# UNITED STATES PATENT AND TRADEMARK OFFICE

# Office Action Summary

10/529,154

## **DETAILED ACTION**

FIG. B, as annotated by the Examiner; Dimensions 1 and 2, defining the first and second open areas between the partition and the fan in both the radial and frontal directions

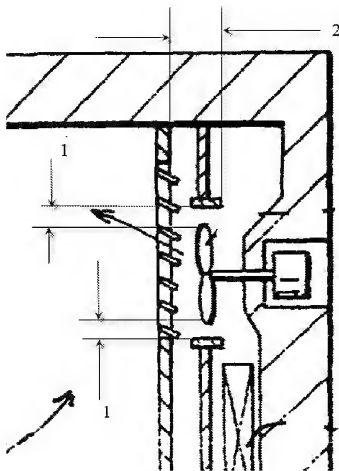
In reference to the applicant's arguments regarding the Kim reference and the inherent phenomenon of two air flow collision, looking at FIG. B (as annotated by the Examiner), the space surrounding the fan (20, FIG. A) is sufficiently open to inherently provide movement of air flow in both directions. Specifically, the first area (defined by offset dimensions 1, FIG. B) provides ample open space in the radial direction and the second area (defined by offset dimension 2, FIG. B) provides ample open space between the partition and the fan. Again, it has been held that a claim is anticipated if each element of the claim is found, either expressly described or under principles of inherency, in a single prior art reference, or that the claimed invention was previously known or embodied in a single prior art device or practice. *Kalman v. Kimberly-Clark Corp.*, 218 USPQ 789. Also, it is elementary that the mere recitation of a newly discovered function or property, inherently possessed by things in the prior art, does not cause a claim drawn to distinguish over the prior art. Additionally, where the Patent Office has reason to believe that a functional limitation asserted to be critical for establishing novelty in the claimed

subject matter may, in fact, be an inherent characteristic of the prior art, it possesses the authority to require the applicant to prove that the subject matter shown to be in the prior art does not possess the characteristic relied on. In *re Swinehart*, 169 USPQ 226 (CCPA 1971).

FIG. A, as annotated by the Examiner: A Cooling Device

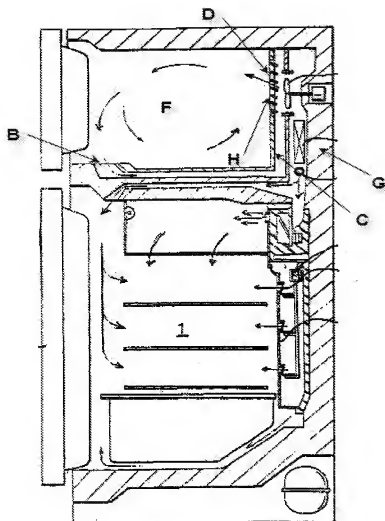
In reference to claim 1, Kim teaches a cooling device (FIG. 2) comprising a cooler (11, FIG. 2) provided on at least one side-wall side (G, FIG. A, as annotated by the Examiner) formed with a thermal insulating box (inherent in a freezer construction as shown in Kim, see FIG. 2); a

cooling chamber (F, FIG. A) in front of the cooler (11, FIG. 2); and a fan (20, FIG. 2) that allows air in the cooling chamber to flow, wherein the cooler and the cooling chamber are partitioned by a partition (C, FIG. A) so as to allow cold air to be accumulated in the cooler, the fan (20, FIG. 2) is disposed on a side of the cooler (11, FIG. 2) relative to the partition (C, FIG. A), the partition in front of the fan (20, FIG. 2) has an aperture (D, FIG. A) formed in a flat sheet portion (above and below partition C, FIG. A), a first open space is formed between the fan and the flat sheet portion in which the aperture is formed (as defined by dimensions 1 plus fan propeller length and 2, FIG. B, above) and a second open space is formed outside the fan in the radial direction (as defined by dimensions 1 plus fan propeller length and propeller width, FIG. B above), cold air accumulated in a space inside the partition, and hot air in the cooling chamber are exchanged by the fan (20, FIG. 2) through the aperture (D, FIG. A), wherein the rotation of the fan generates a discharged flow of cold air discharged from the cooler to the cooling chamber through the aperture and a sucked flow of cold air sucked from the cooling chamber to the cooler through the aperture, and the discharged flow and the sucked flow directed from the cooling chamber to the cooler collide with each other in a portion in which the aperture is provided (inherent in the structure as described in Kim, see FIG. 2), but does not teach that the perimeter of the fan is not surrounded by a cylindrical component. Lazar teaches a forced convection evaporator (FIG. 3) wherein a fan (58, FIG. 3) is located inside the casing (2, FIG. 3) and wherein said fan is not surrounded by a surrounding component in order to allow the fan to suck the cooled air from entire space inside of the casing, including the bottom area of the casing (where the evaporator 28 is located) and disperse said area in the opposite direction towards the discharge (66, FIG. 2 and 4) and thus increasing the efficiency of the refrigerating system (col 2,

In reference to claim 2, Kim, Lazar and Clark disclose the cooling device as explained in the rejection of claim 1, and Kim also teaches that dimensions of the aperture (D, FIG. A) are larger than a diameter of the fan (20, FIG. 2).

direction of a rotation shaft of the fan, the fan is disposed in the aperture (D, FIG. A) and there is an open space outside the fan (in front and around of fan 20, FIG. 2).

In reference to claim 5, Kim, Lazar and Clark disclose the cooling device as explained in the rejection of claim 1, and Kim also teaches that the discharged airflow and the sucked flow collide with each other, thus suppressing the flow speed of the cold air (inherent in the structure as described in Kim, see FIG. 2 and FIG. A).

In reference to claim 8, Kim, Lazar and Clark disclose the cooling device as explained in the rejection of claim 1, and Kim also teaches that a slit (B, FIG. A) is formed in the partition (C, FIG. A) at a portion below the cooler (11, FIG. 2).

In reference to claim 10, Kim, Lazar and Clark disclose the cooling device as explained in the rejection of claim 1, and Kim also teaches that a safety cover (grille H, FIG. A) is disposed over the fan aperture (D, FIG. A).
